Interactive comment on “The effect of water storage change in ET estimation in humid catchments based on Budyko framework and water balance models” by Tingting Wang et al.

Tingting Wang et al.

Interactive comment on Hydrol. Earth Syst. Sci. Discuss., <https://doi.org/10.5194/hess-2017-151>, 2017.

Fig. 1. Figure 5 The box plot of R^2 between monthly ET_{wb} and ET_{budyko} using the extended Budyko equation, i.e., $P-\Delta S$ as equivalent P , and ΔS is obtained from abcd model.

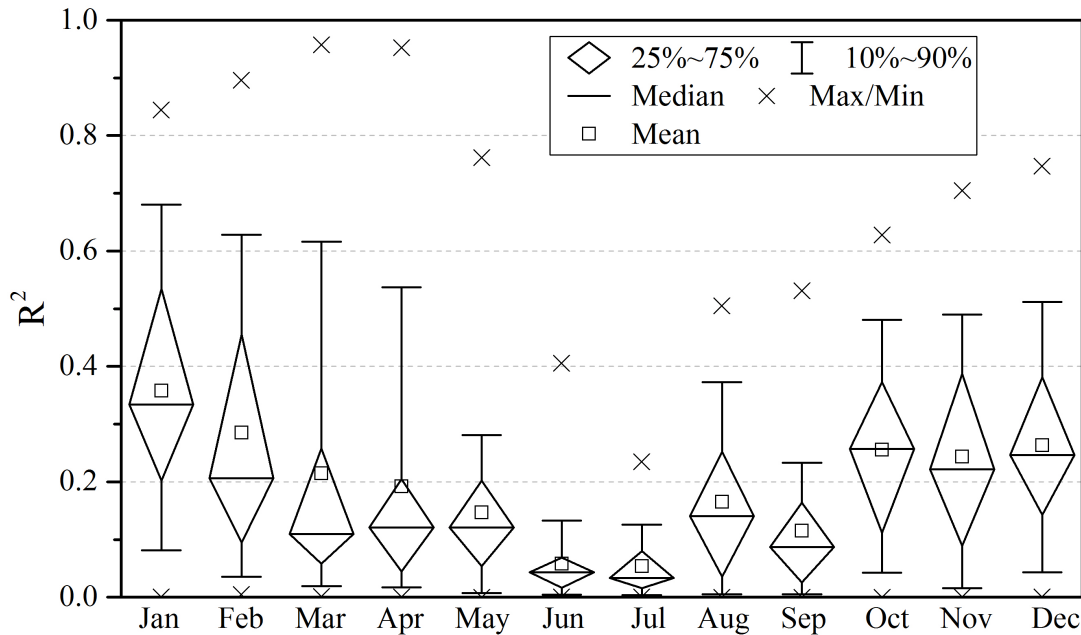
This study analyzes the effect of changes in water storage at annual and multi-annual timescales for humid catchments in China. The authors perform a quantitative comparison of evapotranspiration (ET) estimates from the water balance, Budyko's framework, and two other models. They show that it is erroneous to obtain annual ET estimates from the water balance when neglecting changes in storage. I find the approach interesting, but numerous points need to be addressed. Particularly, the quality of the text needs to be greatly improved before being able to thoroughly assess the scientific merit of the study.

Thank you for your invaluable comments/suggestions sincerely! Detailed point to point response is as below. It is worth mentioning that we have added the result about the effect of ΔS on annual ET estimation based on Budyko framework in section 3.3. It shows that almost no improvement has been made in annual ET estimation based on the extended Budyko equation (Figure 6), which uses $P-\Delta S$ as 'equivalent' precipitation at monthly timescale through high R^2 achieved (Figures 5 and 6), which is due to the seasonal pattern within the year. This further supports our conclusion that the common practice of ignoring annual ΔS in water balance, can lead to larger deviation in estimated ET assessment in humid catchments. Without reliable ΔS , ET estimation in humid catchments remains an important scientific challenge.

Fig. 3. Figure 9 The annual time series of PET, ET_{wb} , ET_{budyko} and $ET_{budyko} + \Delta S$ over 1957-2013 for the selected typical catchment (a), and (b) the comparison between ET_{budyko} , $ET_{budyko} + \Delta S$ against ET_{wb} in t

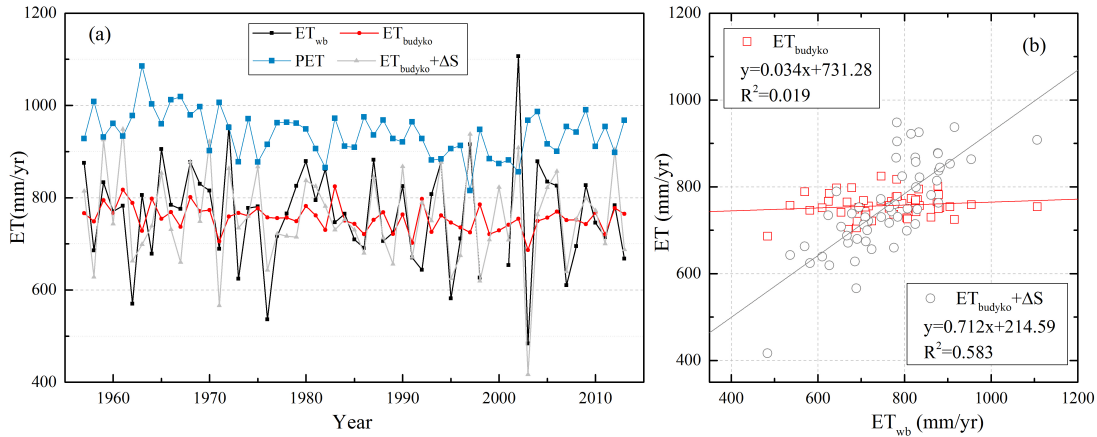
The approach for analyzing the inter-annual variability of ET needs to be clearer (equations 8 and 9). Is the effect of ΔS not accounted for? I believe it would be better to not include this section in the paper, and consequently Figure 10b. The authors already convey your point about the higher variability of ET_{wb} compared to the other estimates

of ET in Figure 10a. They could strengthen this argument by showing the histograms or pdfs of P, PET, and ET. It may be also possible to identify years with $\Delta S > 0$, for which $ET_{wb} > PET$. I would also recommend plotting the time series of PET in Figure 8.

Indeed. We have removed this part from the manuscript since they are less relevant to the results. We have added the time series of PET in Figure 9a.
